# FAIRFAX COUNTY

## STAFF REPORT

APPLICATION FDP 2000-SU-029-2 and 2232-Y01-2

**PROPOSAL:** Final Development Plan Approval to permit  
development of an elementary school and  
community park on 28.44 acres

DATE: FEB 2, 2001  
BY: [Signature]  
SCALE: 1" = 40' (AS SHOWN)  
SHEET NO. 4 OF 7

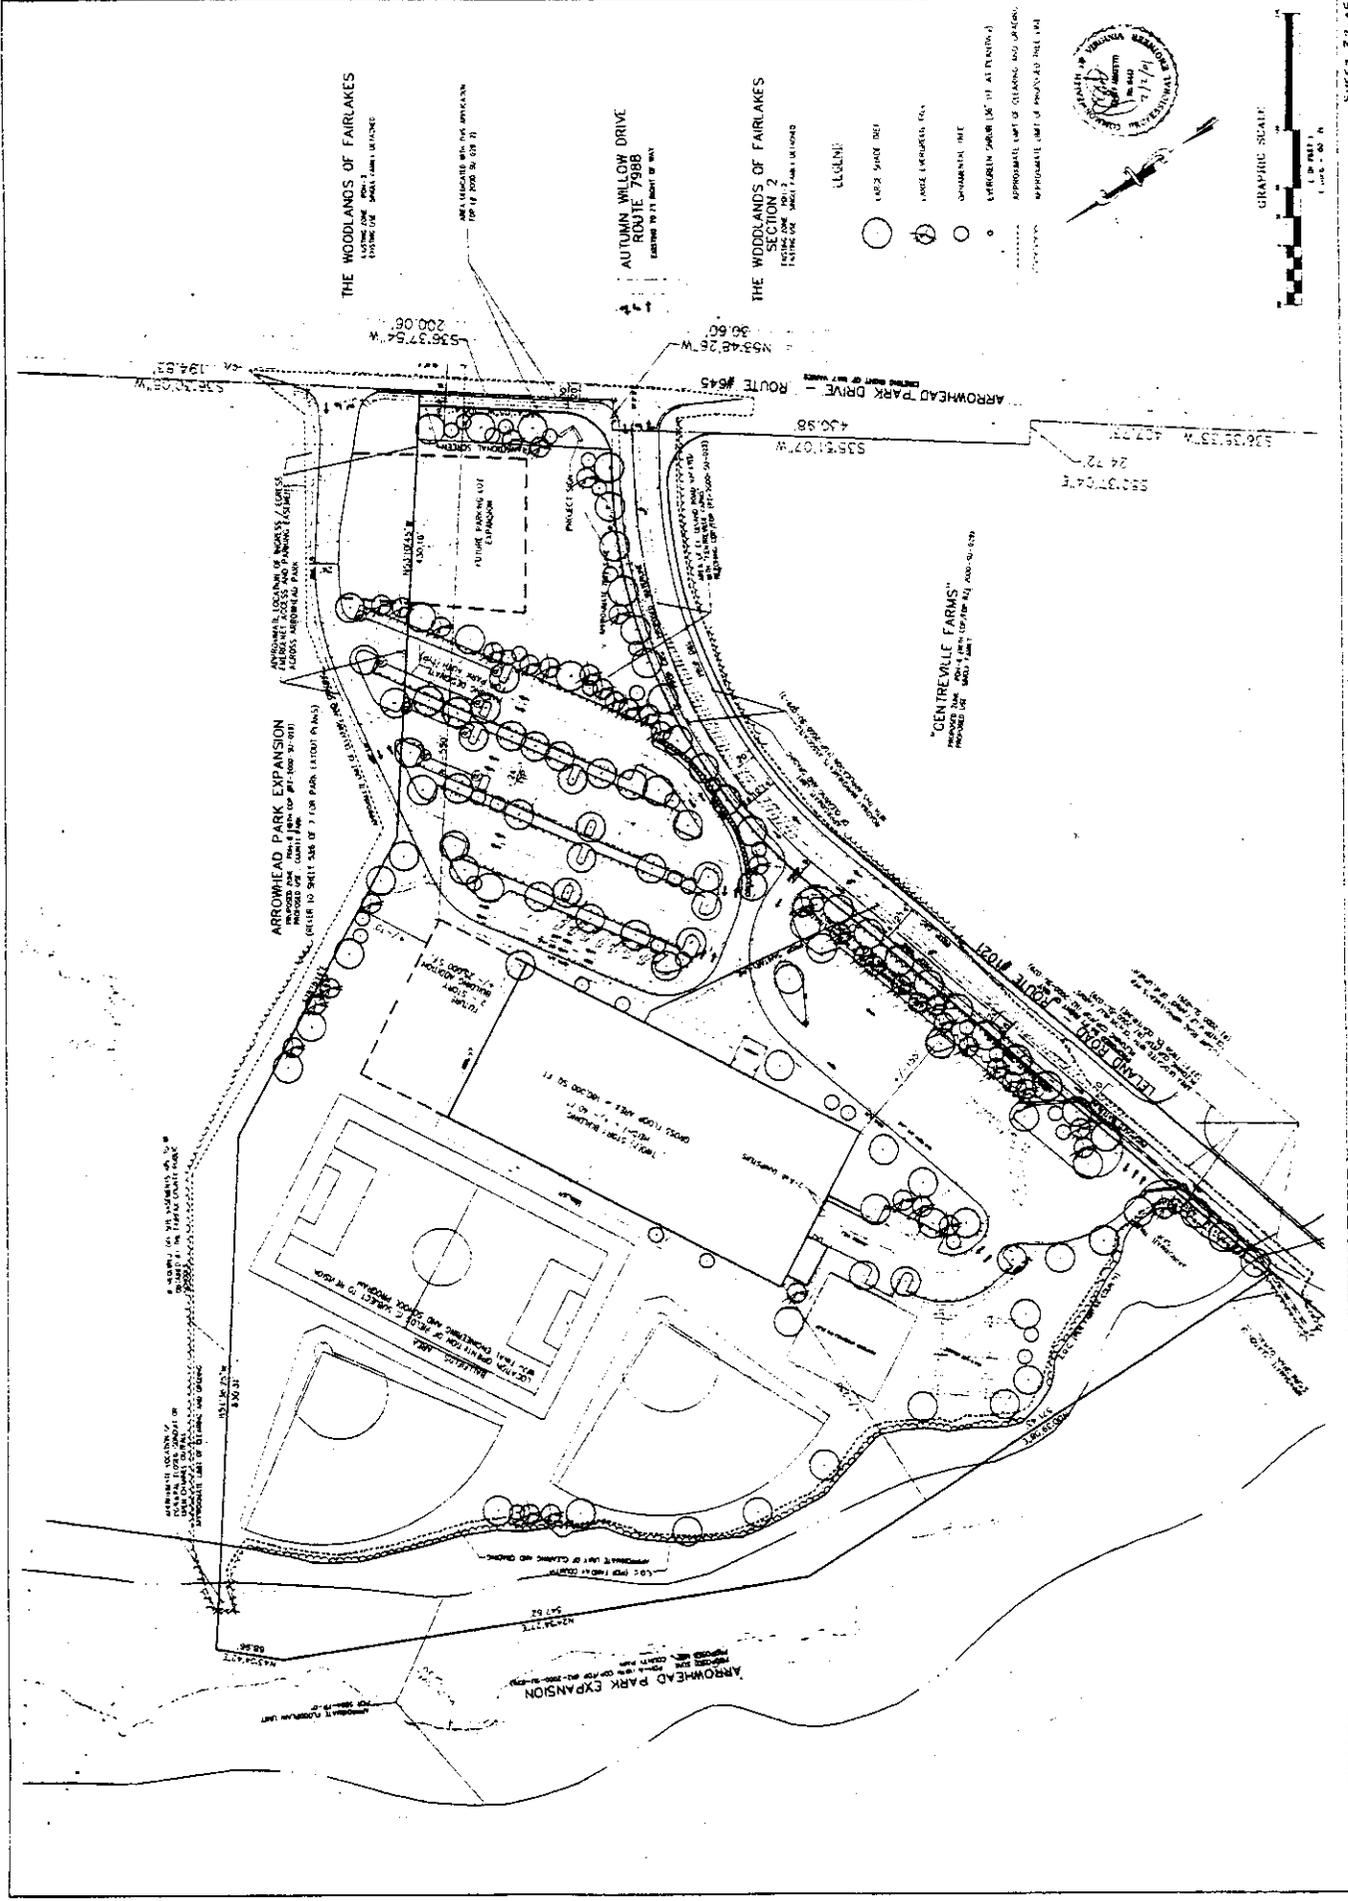
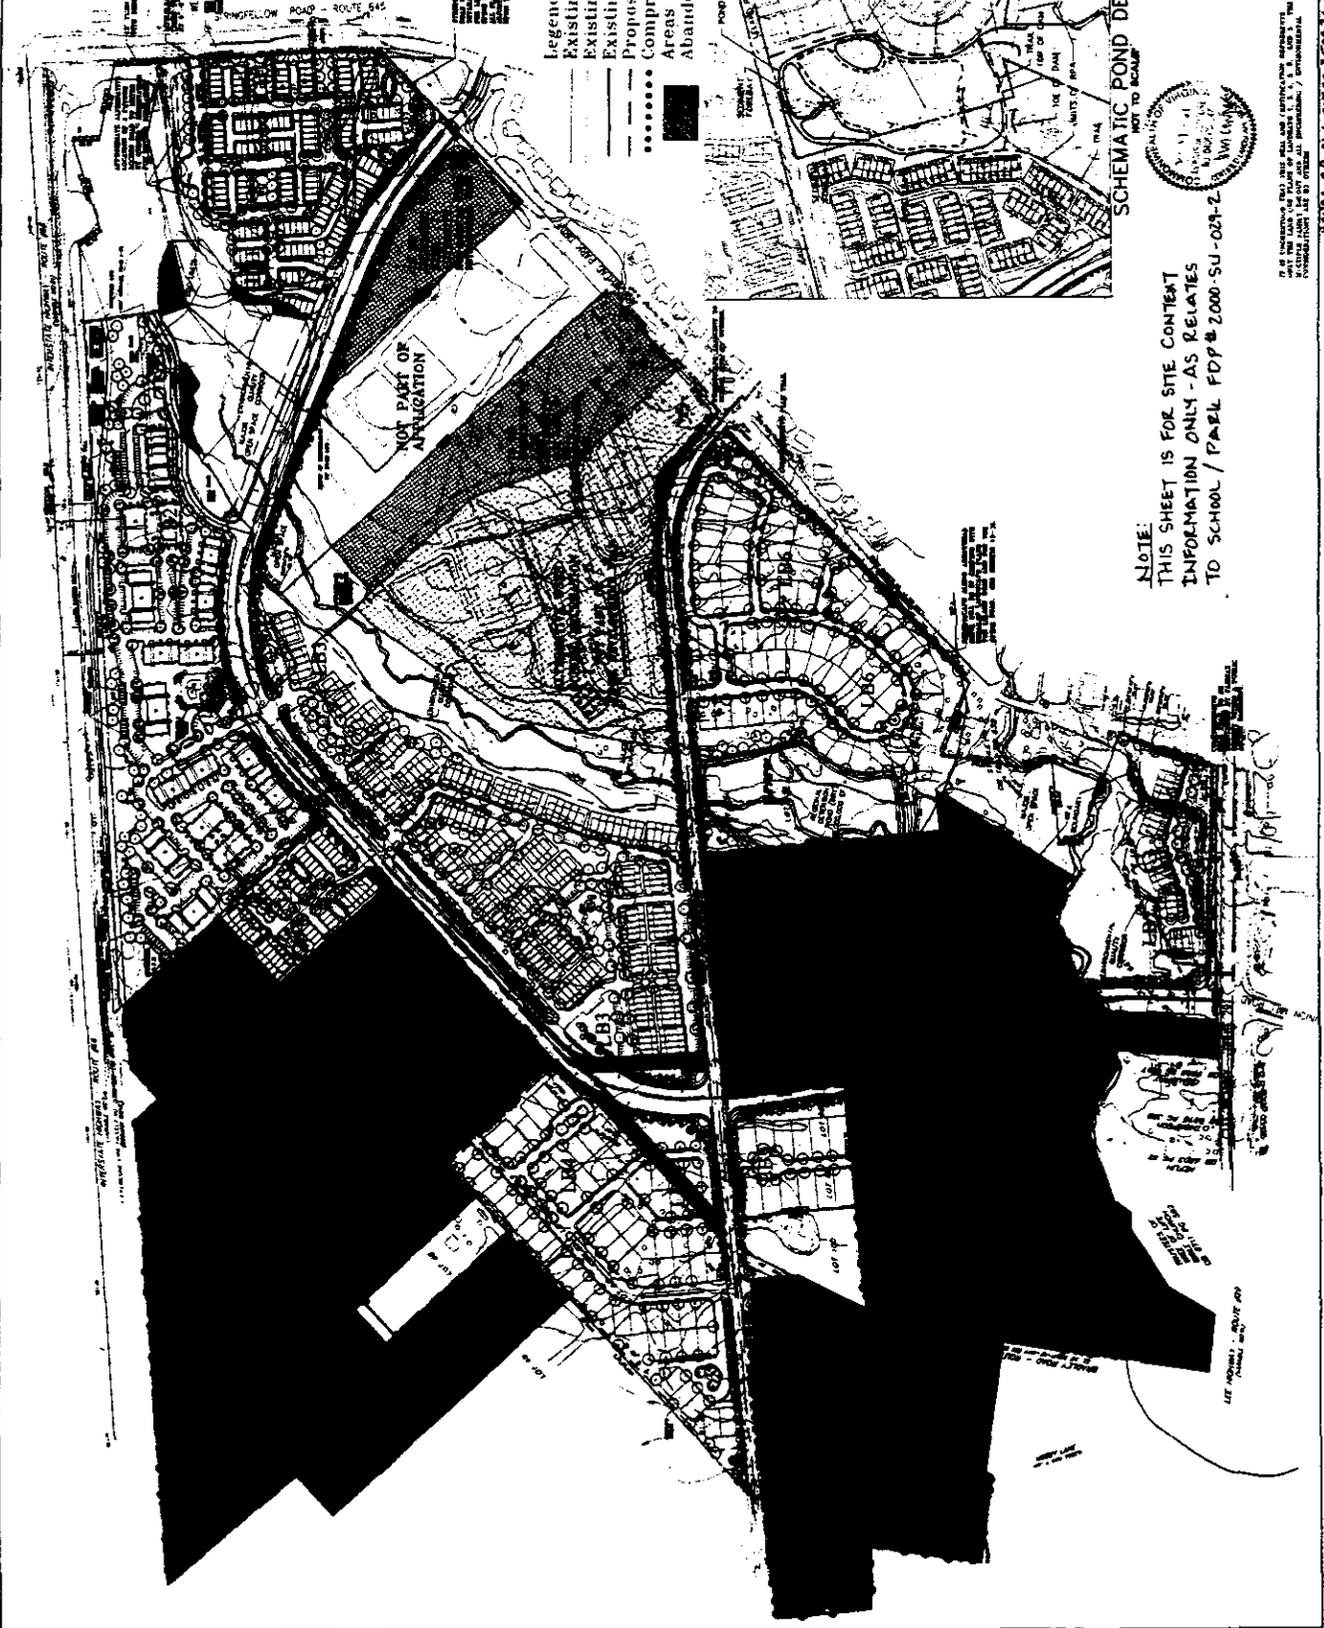
- The FDP should reflect the general location, number and height of light poles. At this time the FDP does not provide this detail. Staff recommends the implementation of a development condition to establish minimum and maximum foot-candle illumination levels in order to achieve an average illumination level of 40 foot-candles on the playing fields and to meet the Zoning Ordinance glare standards which requires that illumination shall not exceed .5 foot candles in any adjacent residential district. In addition, the proposed lighting for the fields should adhere to the lighting concepts and recommended practices expressed by the Illuminating Engineering Society of North America (IESNA) in the document entitled RP-33-99. This would include fully shielded light fixtures that are appropriately focused and positioned and would also include rear shielding of lights.

- A previous version of the FDP depicted a 35 foot wide planted buffer around the northern boundary of the park site and a 50 foot wide buffer along the eastern boundary, adjacent to existing residential development. Staff recommended that the FDP be clarified to indicate that a 50 foot buffer is to be provided along the northern boundary through a combination of existing trees and vegetation and the proposed supplemental 35 foot transitional screening buffer. It was noted that supplemental evergreen tree and understory plantings may be necessary to fully screen the proposed lighted tennis courts from the adjacent residential development, as may be determined by the Urban Forester.

- Staff recommended that the tennis courts be shifted further away from the site frontage and re-oriented to provide a deeper buffer in order to minimize both visual and noise impacts on the residential development across Arrowhead Park Drive.

- All parking lot lighting should feature full-cut-off fixtures to minimize any off-site glare. A development condition has been prepared to address this issue.
- A pedestrian walkway should be provided around both sides of the existing Arrowhead Park parking lot in order to provide safe and convenient access to the tennis courts and fields north of the parking lot and sidewalks should be provided along both sides of the shared park/school access drive.

The FCPA has indicated that the proposed lighting system for the fields will provide an average 30 foot candle illumination level on the fields and will not exceed the Zoning Ordinance glare standards of .5 foot candles at the periphery of those portions of the site adjacent to residential development. The FCPA proposes to utilize a four light pole design for each field, except Field 4 which may utilize a six pole design to accommodate the proposed use of this field as two smaller fields. While the height of the poles will be 80 feet, the FCPA has committed to utilize fully shielded fixtures with rear shielding to minimize spillover effects. Staff has prepared a development condition which incorporates the above-referenced commitments.

The FDP has been revised to indicate that the buffer will consist of a combination of tree preservation and supplemental landscaping which together will be on average a minimum of 50 feet in width. Staff has prepared a development condition requiring the FCPA to work with the Urban Forestry staff at the time of site plan approval to provide for supplemental landscaping where determined necessary to provide an effective year round screen in addition to that shown on the FDP. Staff believes this issue has been adequately addressed with the proposed development condition.

The revised FDP has relocated the tennis courts an additional 10 feet back from the site frontage (from 60 feet to 70 feet) and noted that additional supplemental landscaping may be provided in this area. Staff believes this issue has been satisfied.
